**Standard Permit for Solid Waste Landfill
Granite State Landfill – Phase I
Response to NHDES Incomplete Application (#2021-52265)
Douglas Drive
Dalton, NH 03598**

**RE: Granite State Landfill, LLC
Proposed Lined Landfill – Dalton, New Hampshire
Standard Permit Modification – Application # 2021-52265
Response to NHDES Incomplete Application Correspondence**

Cross Section Location Plan

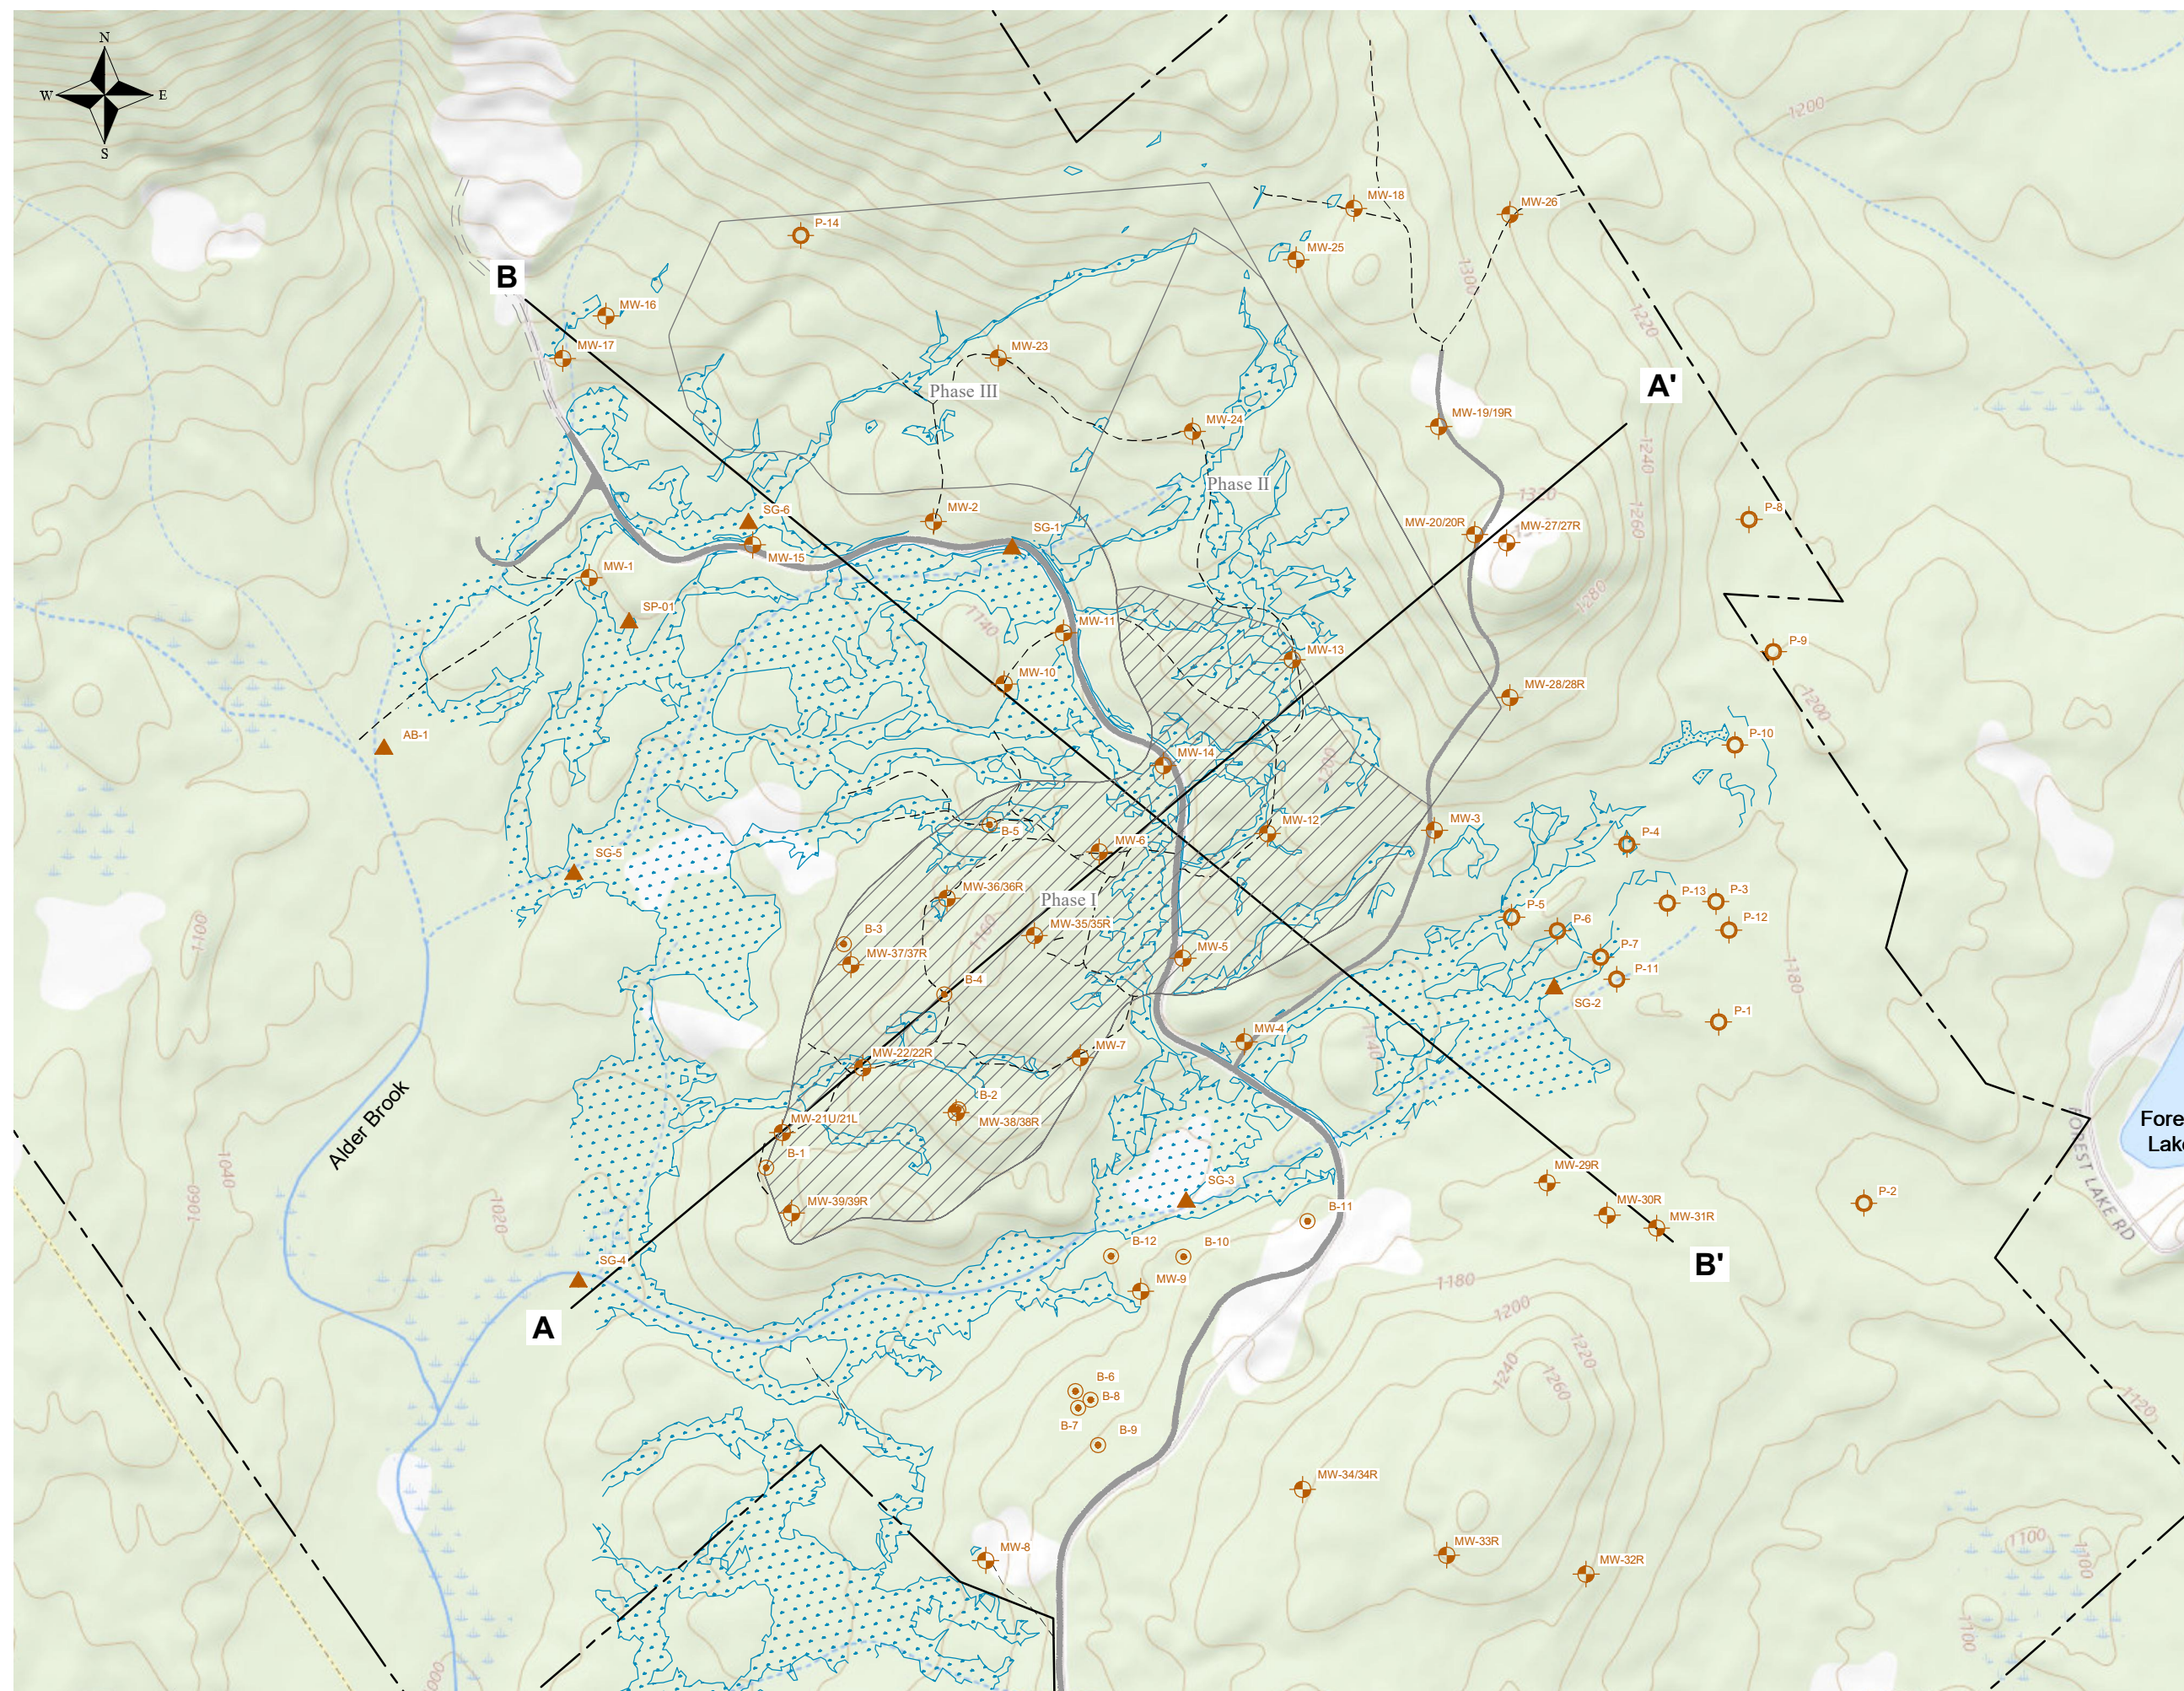
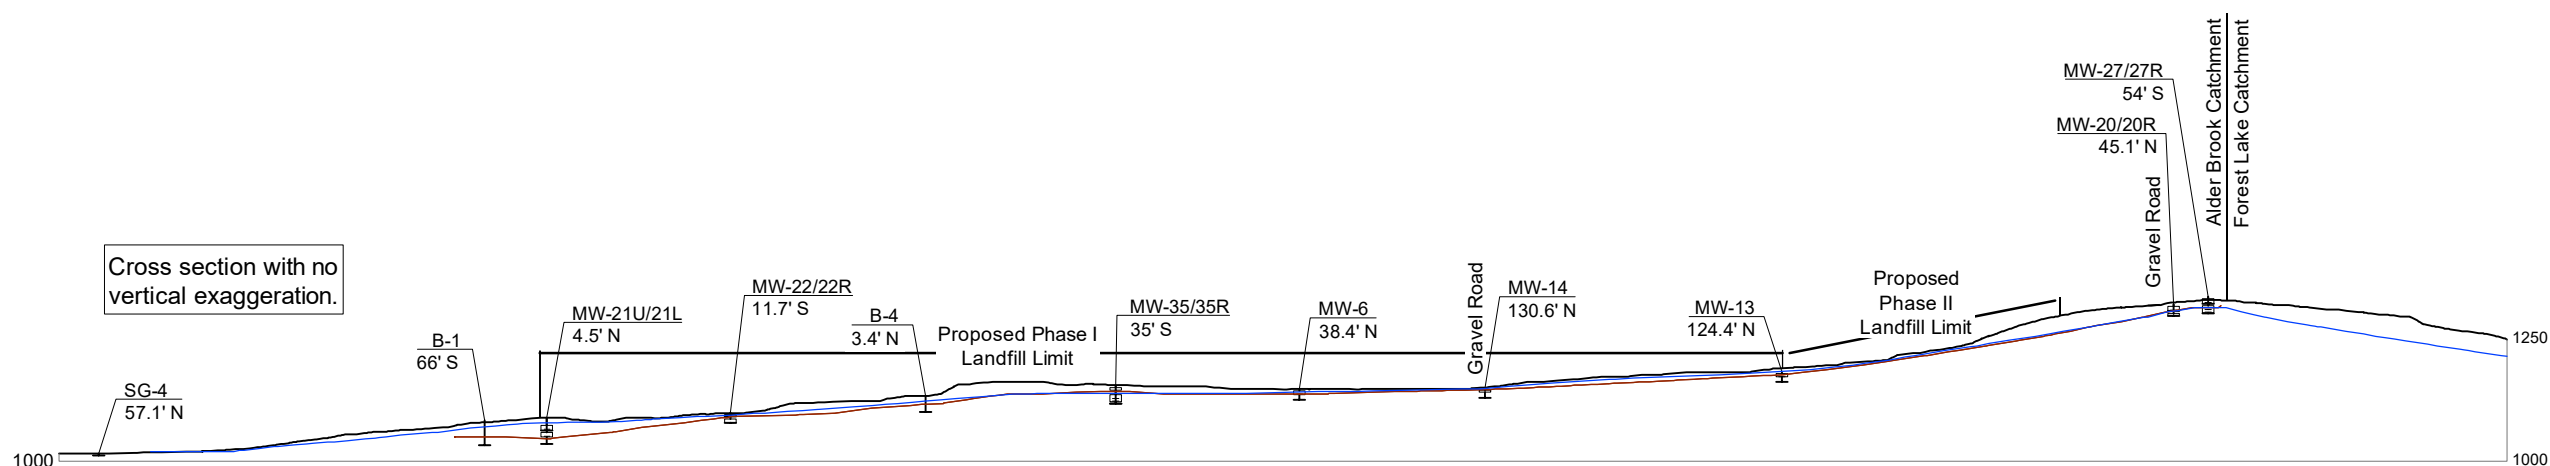
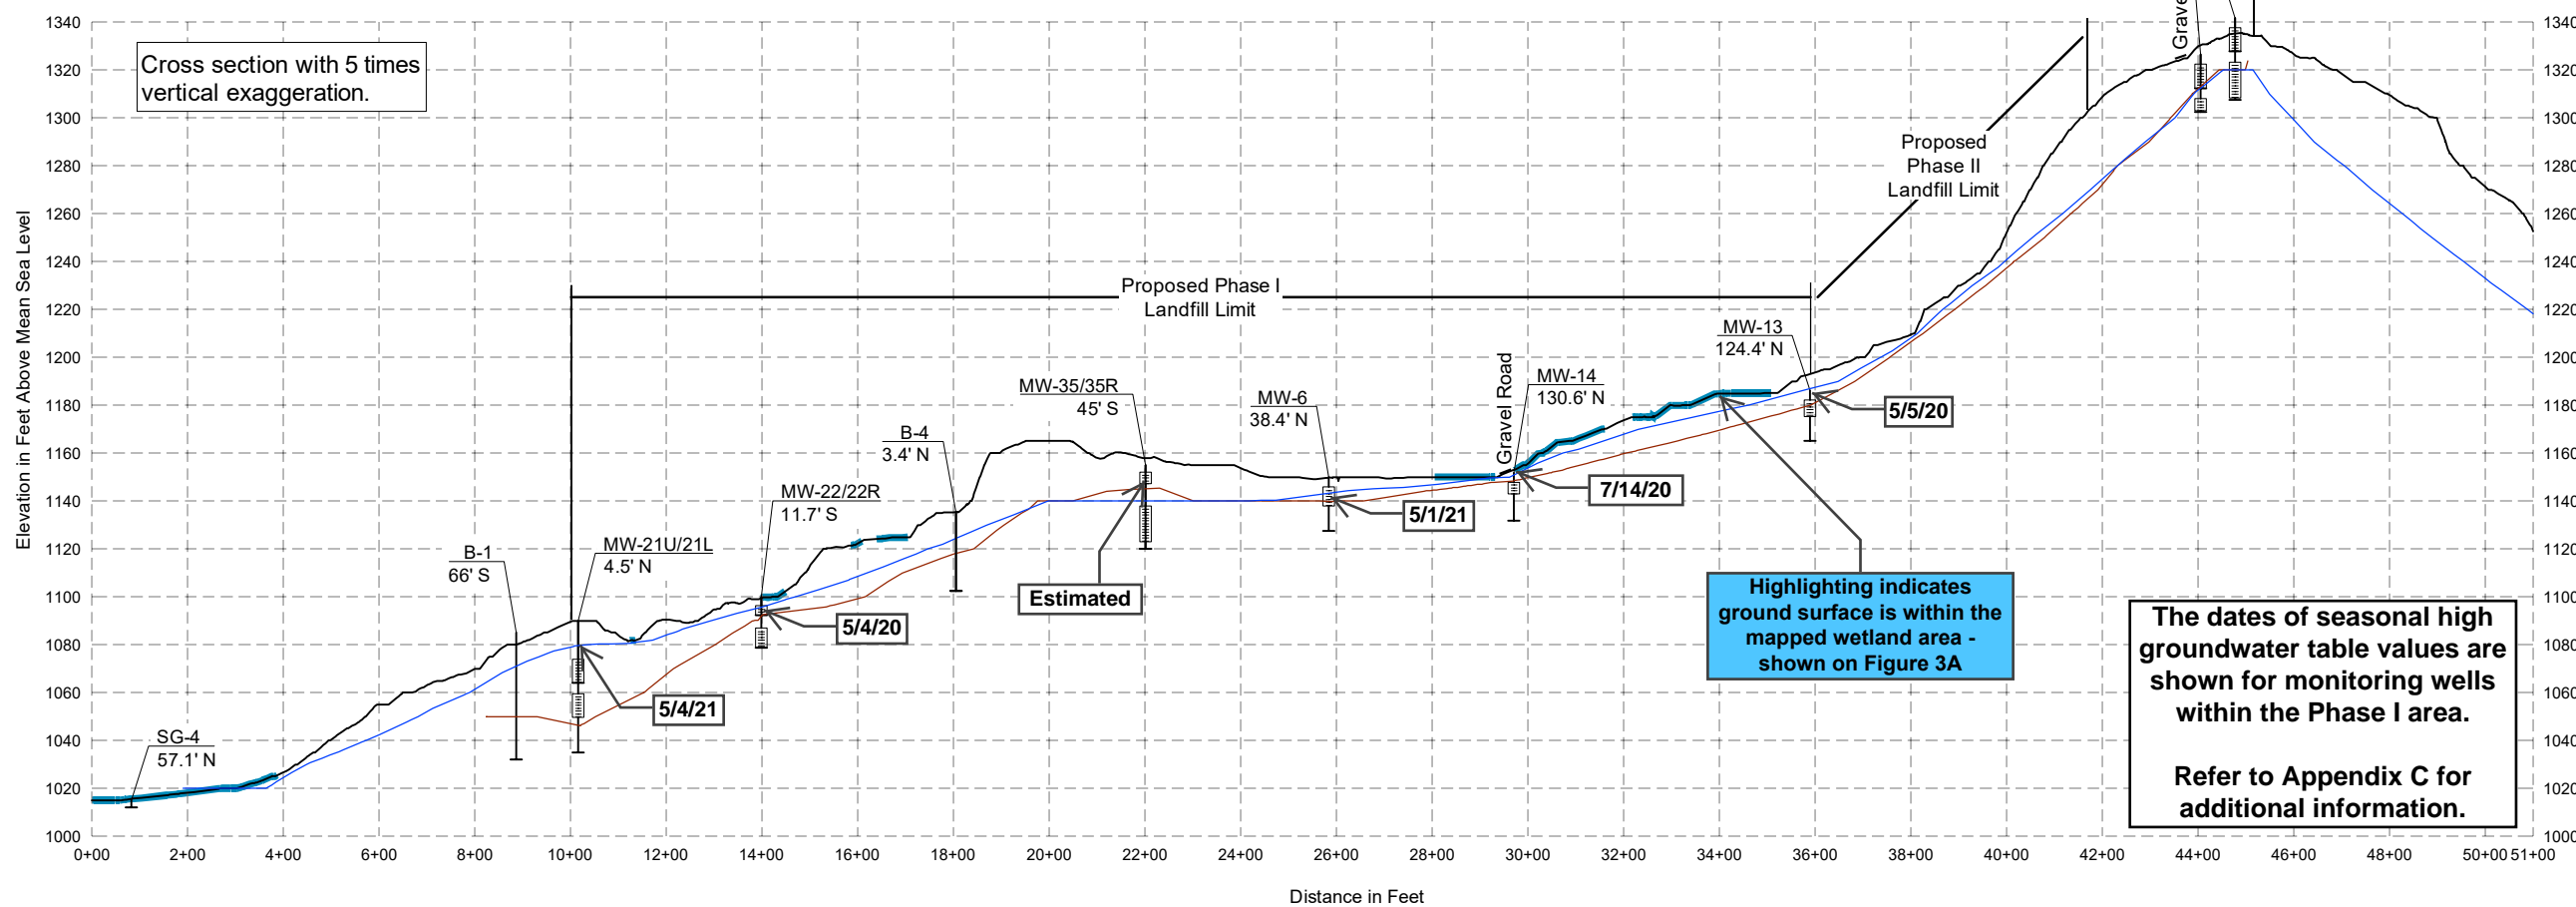
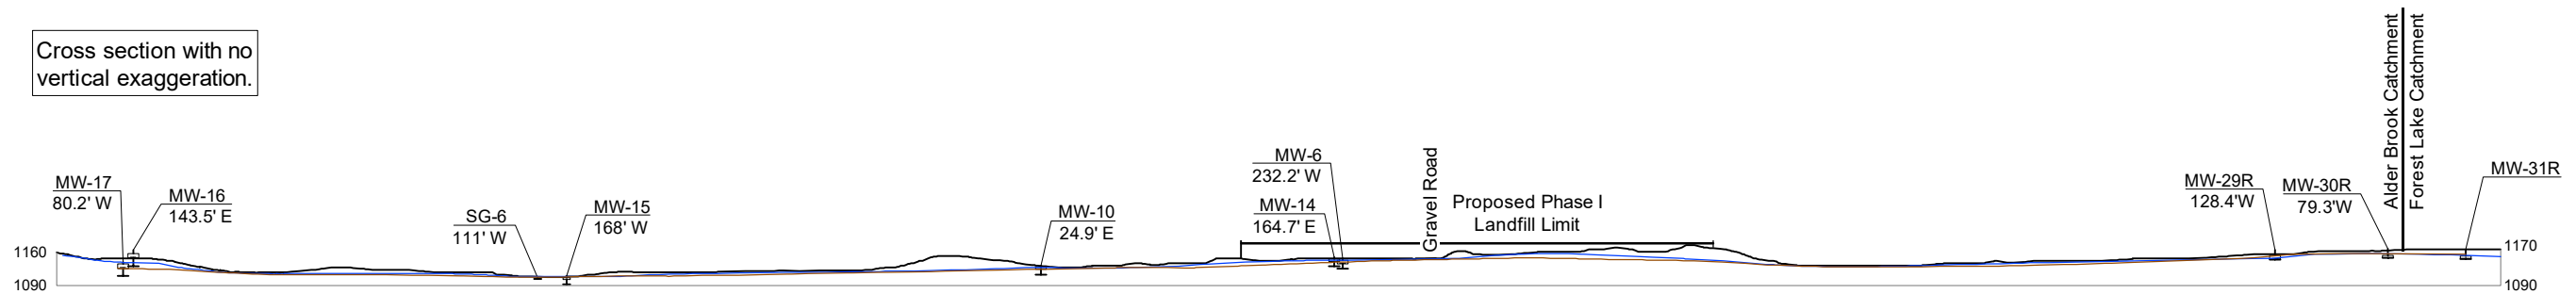
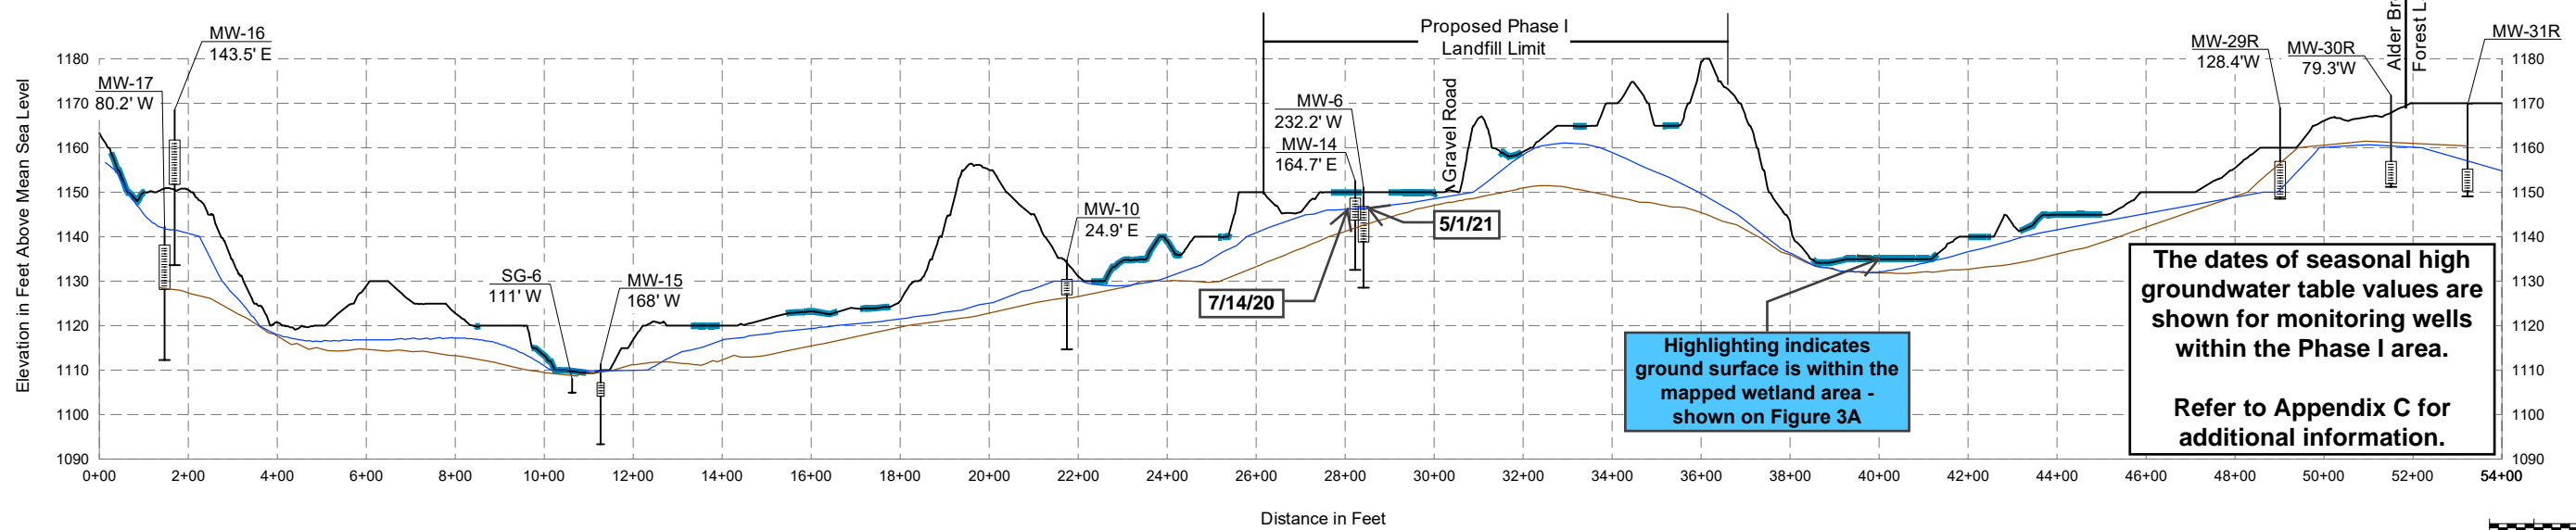
- *Geologic cross-sections, tied to surface (e.g., wetlands as discharge points) and subsurface explorations (e.g., hydrogeological, geotechnical), depicting pertinent features in detail such as the proposed liner, fill, bedrock, and seasonal high groundwater, including a note indicating the date(s) from which the seasonal high groundwater elevations shown were derived.*

Geologic cross-sections, tied to surface and subsurface explorations depicting the existing ground surface, bedrock, and inferred seasonal high groundwater are included in the attached Hydrogeologic Supplement (Figures 3A, 3B and 3C). The cross-sections note the dates from which the seasonal high groundwater elevations shown were derived. Detailed cross-sections depicting the proposed liner, fill, bedrock, and seasonal high groundwater are being prepared and will be provided in a future transmittal.
